ADDENDUM NO. 1

June 22, 2011

Grant County Landfill Complex
Ephrata, WA

Project:	<u>GRANT COUNTY LANDFILL COMPLEX</u>	PN:	<u>1009</u>
Meeting:	<u>Grant County Public Works Administrative Offices</u>	Date:	<u>June 15, 2011</u>
Location:	<u>(Reconvene on Project Site after initial meeting)</u>	Time:	<u>1:00 PM</u>

2/AC102

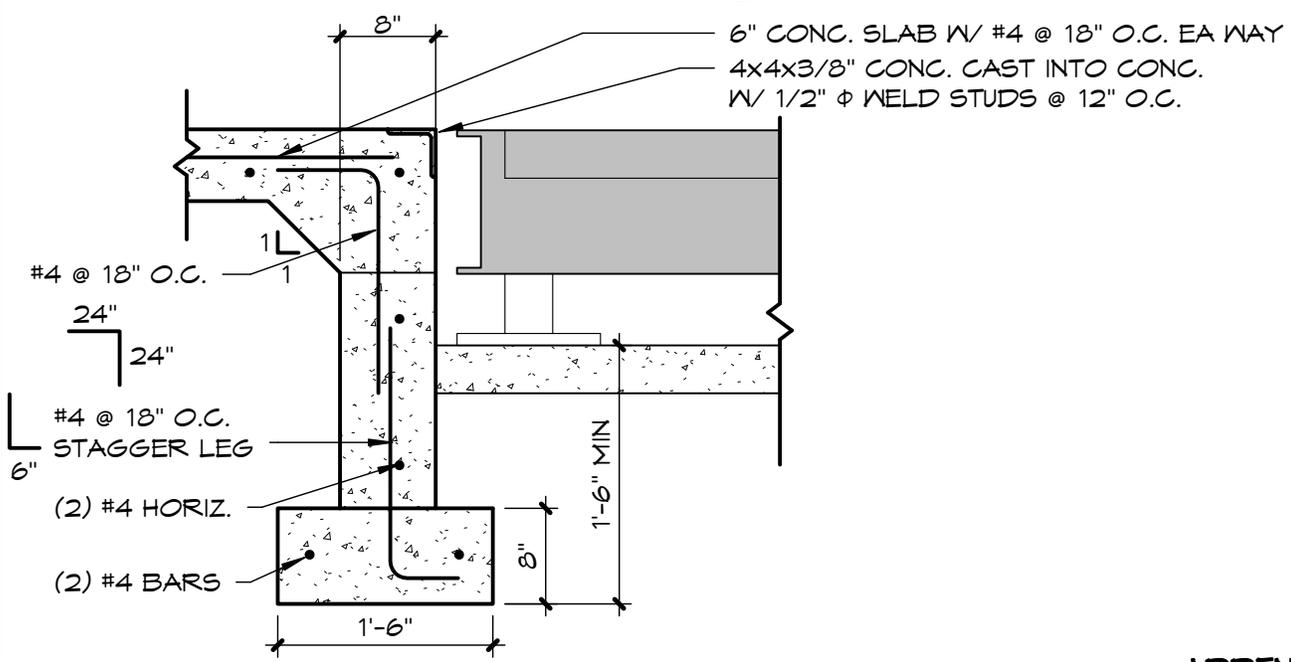
- Item No. 26:** Sheet AC102, Enlarged Site Plan: ADD the following note: “Refer to the attached Detail 2/AC102 for foundation and slab details at weigh scales.”

- Item No. 27:** Sheet AC102, Enlarged Site Plan: ADD Detail 2/AC102 - Foundation at Scale as attached.

3/A101

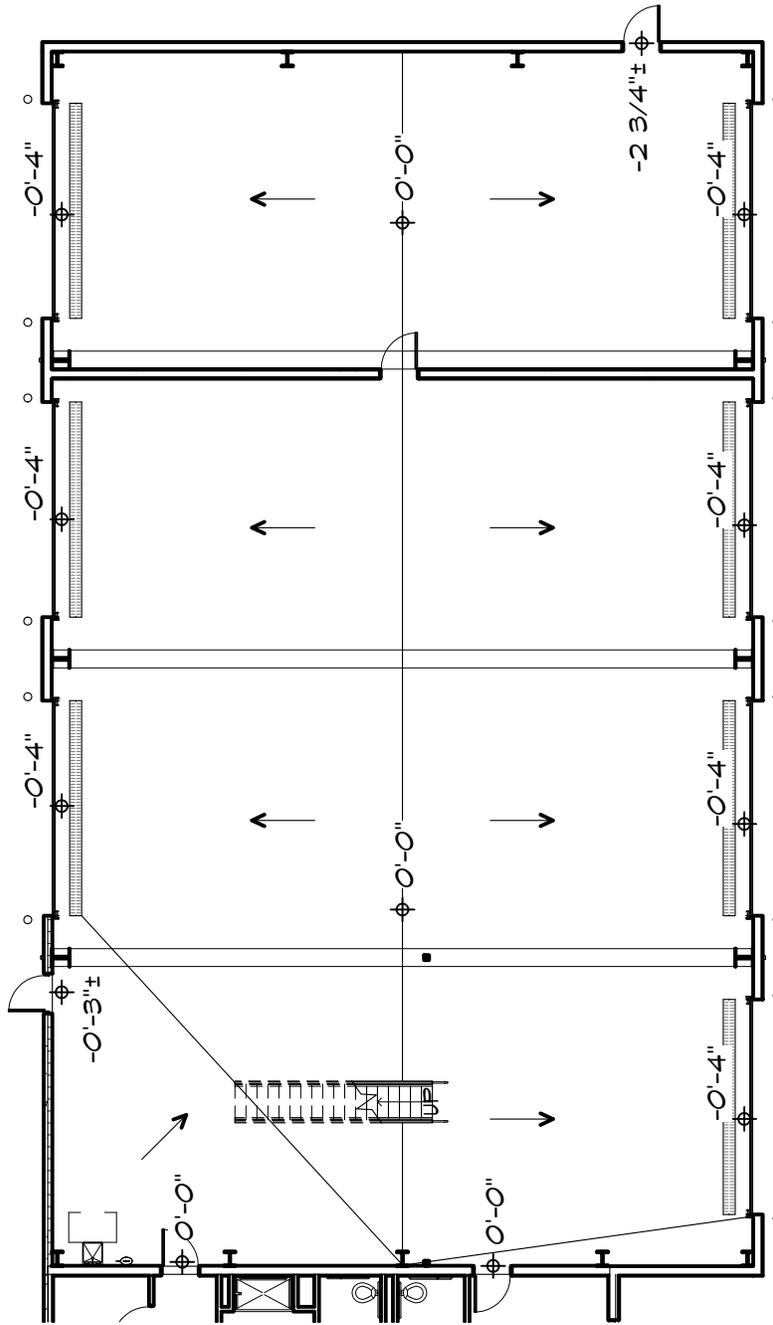
Item No. 32: Sheet A101, Floor Plan - Shop Building: ADD finished floor slab elevations per attached Detail 3/A101.

4/A101

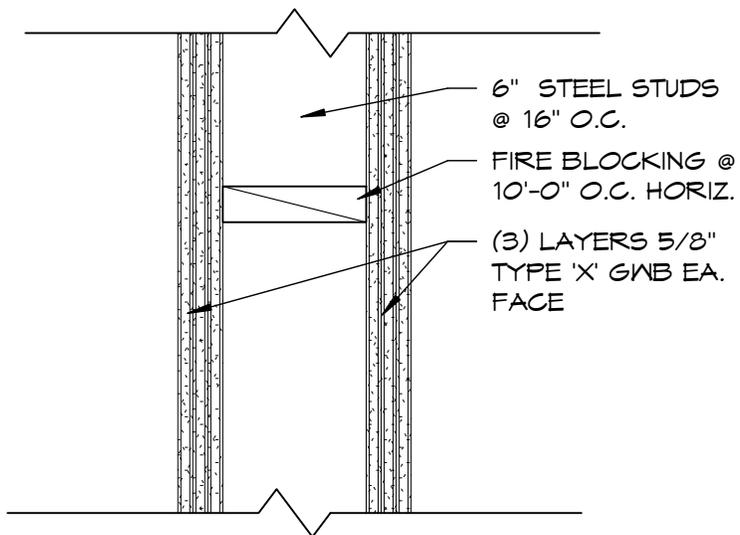
Item No. 33: Sheet A101, Floor Plan - Shop Building: ADD callout for Detail 4/A101 – 3-Hour Fire Partition, as attached.

3/A311

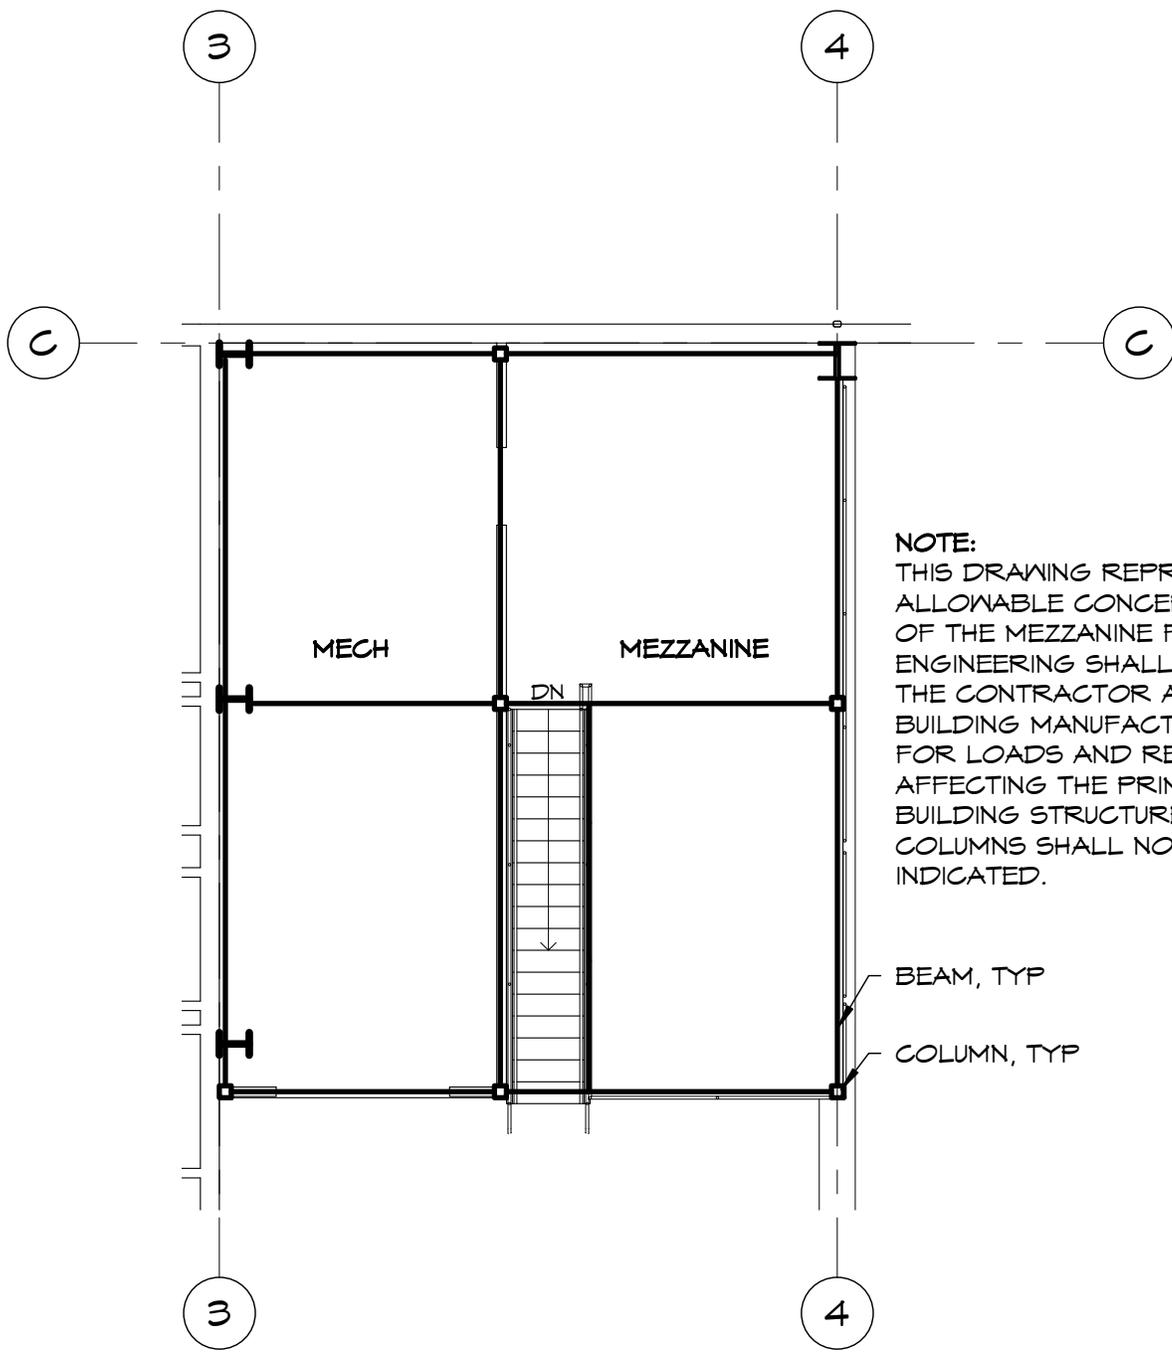
Item No. 37: Sheet A311, Wall Section C - Shop Building: REVISE construction callouts per attached Detail 3/A311.

A/A401

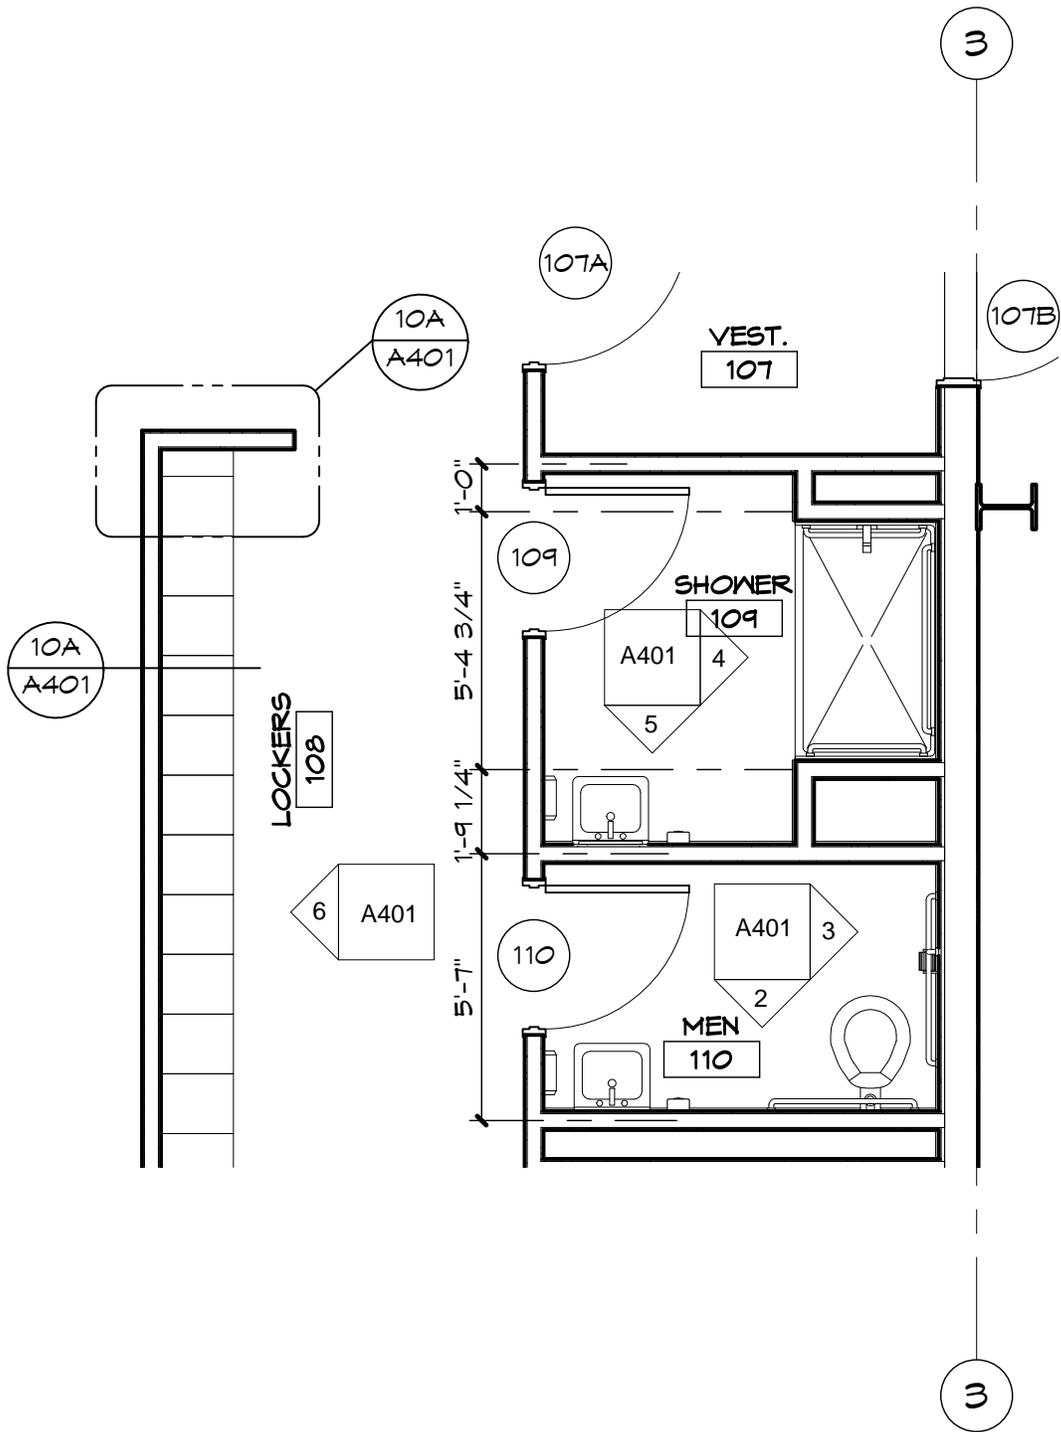
- Item No. 41:** Sheet A401, Detail A, Enlarged Plan - Office Area: REVISE dimensions and callouts per attached Detail A/A401 - Enlarged Office Plan.
- Item No. 42:** Sheet A401, Enlarged Plans, Interior Elevations and Details: ADD Detail 10/A401 per as attached.

18/A501

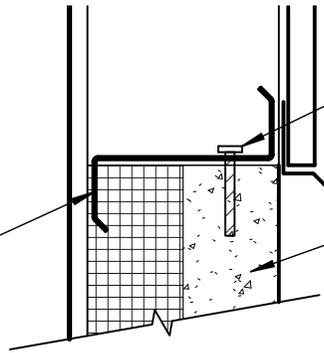
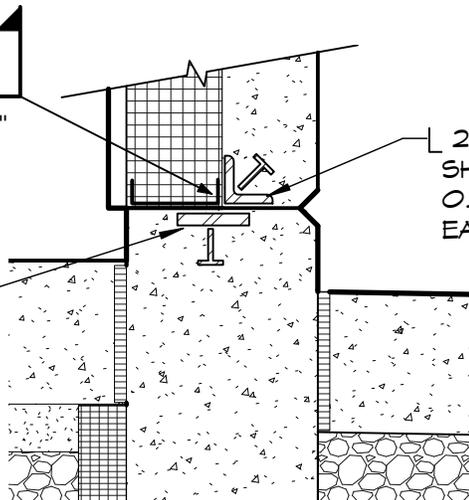
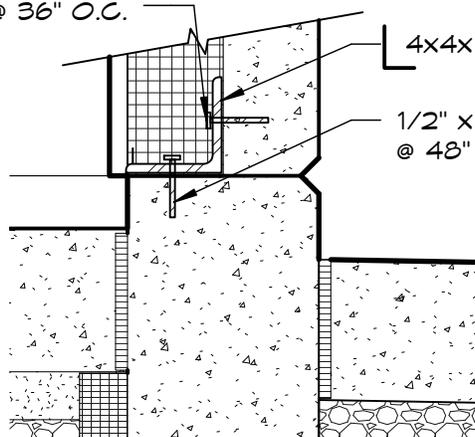
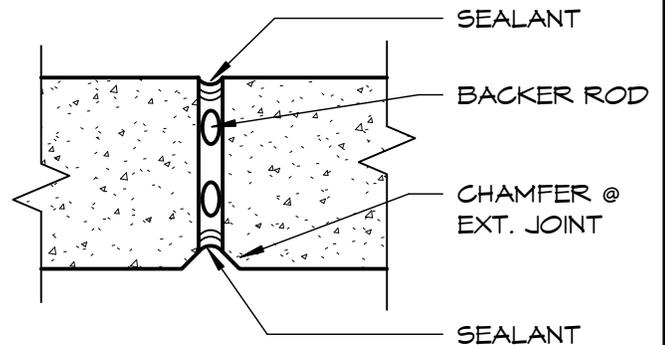
- Item No. 44:** Sheet A501, Details: ADD Detail 18/A501 – Pre-Cast Concrete Panels, as attached.
- Item No. 45:** Sheet A601, Room Finish Schedule: ADD the following note:
“All exposed steel shall be field painted. Refer to specifications for shop priming of metal building components.”
